City of Richmond

Report to Committee

Re: Application by Inter Luck Trading Corp. for Rezoning at 3560 Moncton Street from Steveston Commercial (CS2) to Commercial Mixed Use (ZMU43) - Steveston Village

SITE PLAN WITH
GROUND FLOOR
LAYOUT

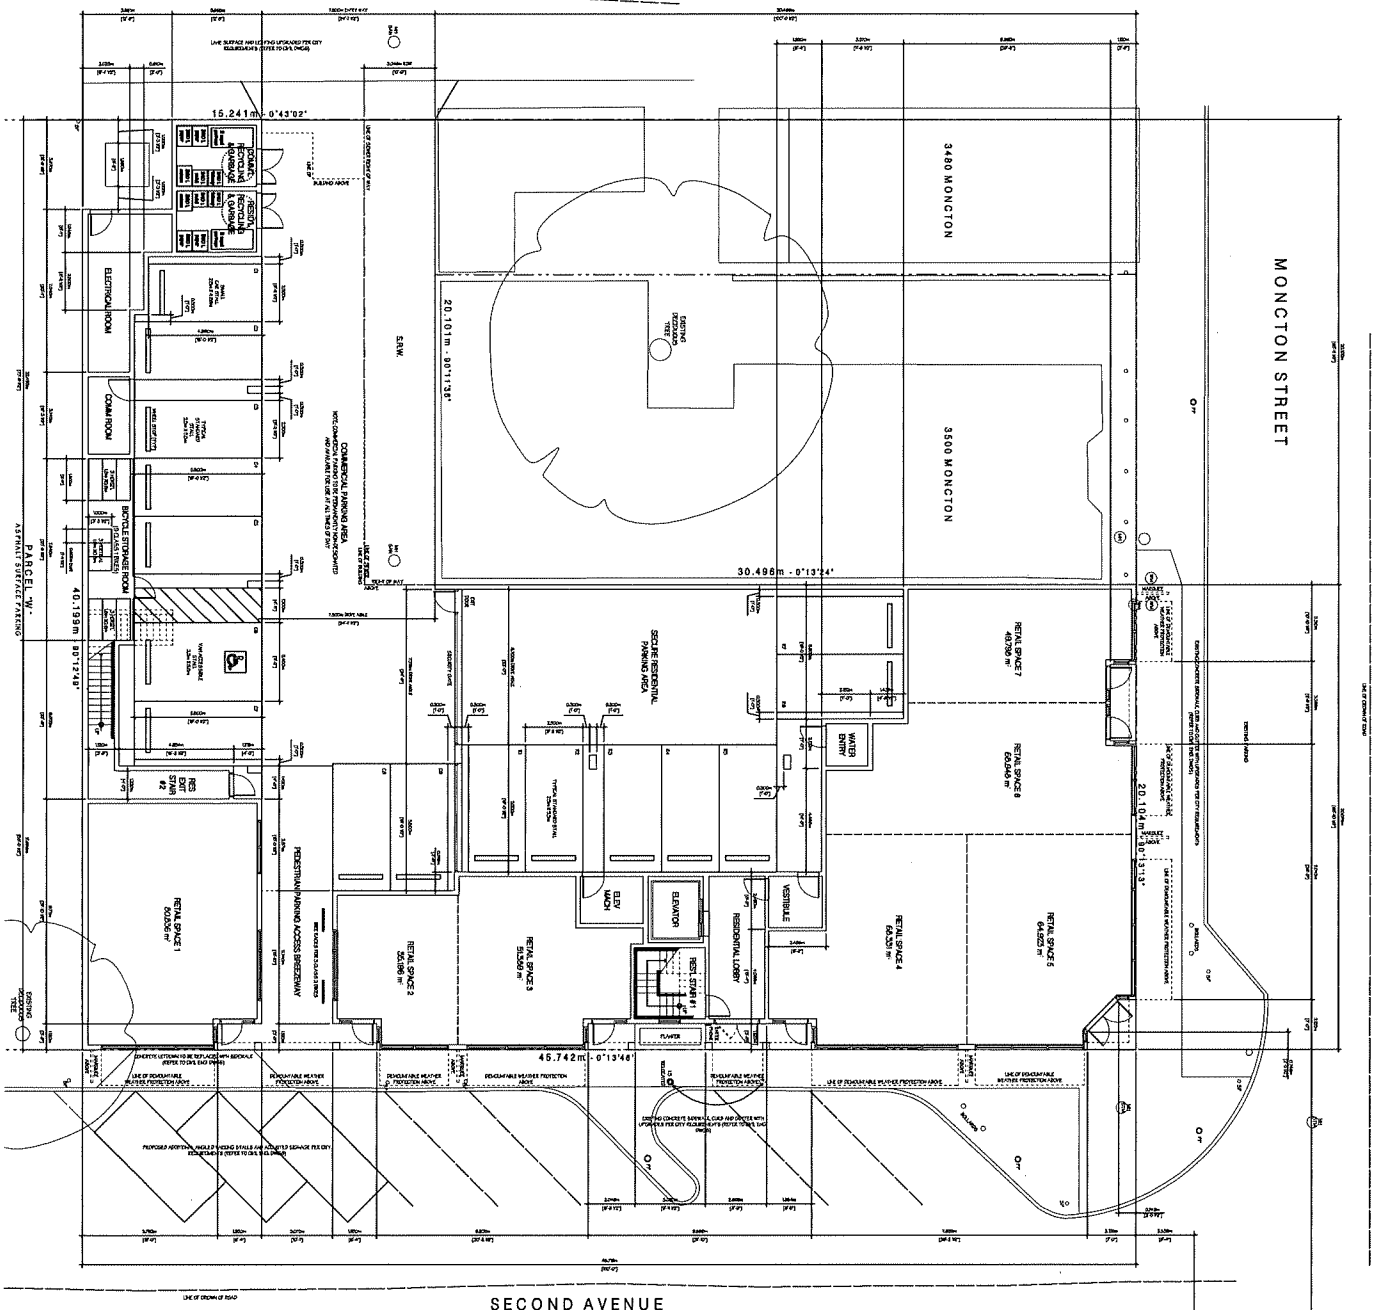
RESPONSE TO ADP COMMENT
5
RESPONDING TO PLANNING CITE
SITE COVERAGE AREAS ADDED
REMOVED ROOF DECK AREA
REMOVED ROOF AREA AND ROOF DECK

VIEW ANALYSIS
WITH
STREET VIEWS
AND
PERSPECTIVES

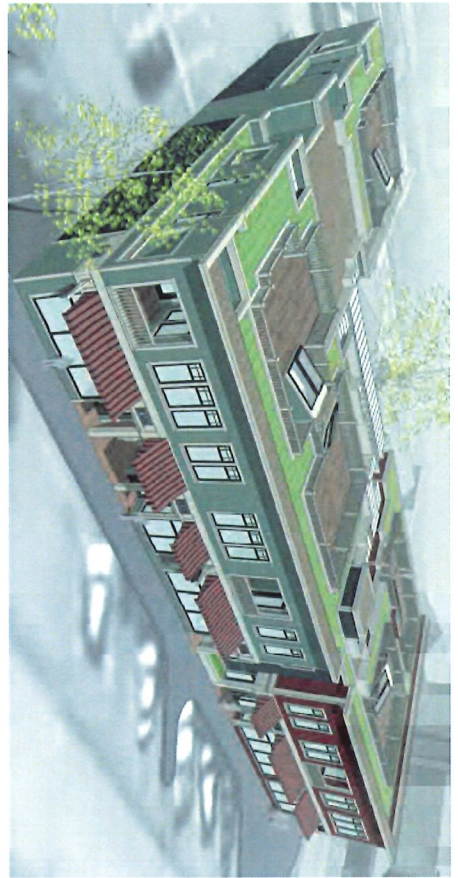
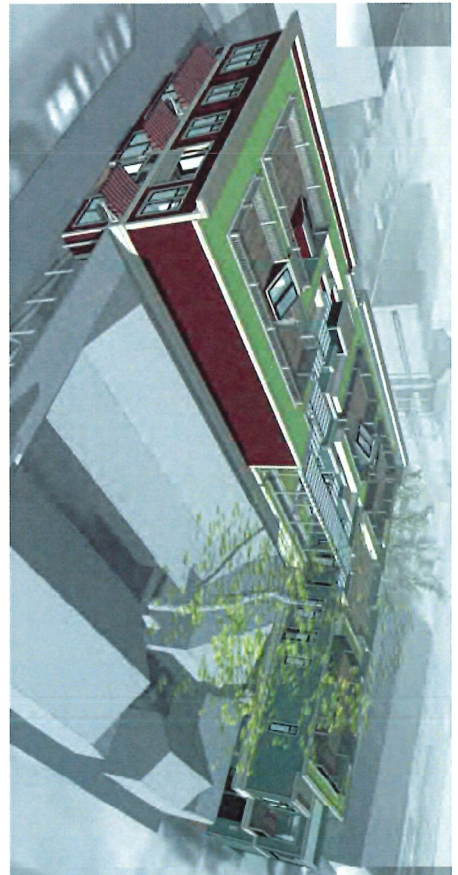
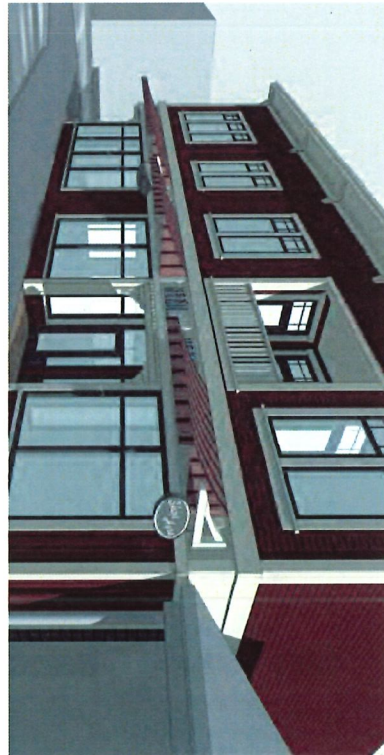
RESPONSE TO ADP COMMENTS
REMOVED MONCTON JARRETTE BALCONY
UPDATING TO PLANNING CITE
STREET VIEWS ADDED
CHANGES AT RUMP SIDE LEVEL SHOWN
REVISIONS FROM PREVIOUS SUBMISSIONS
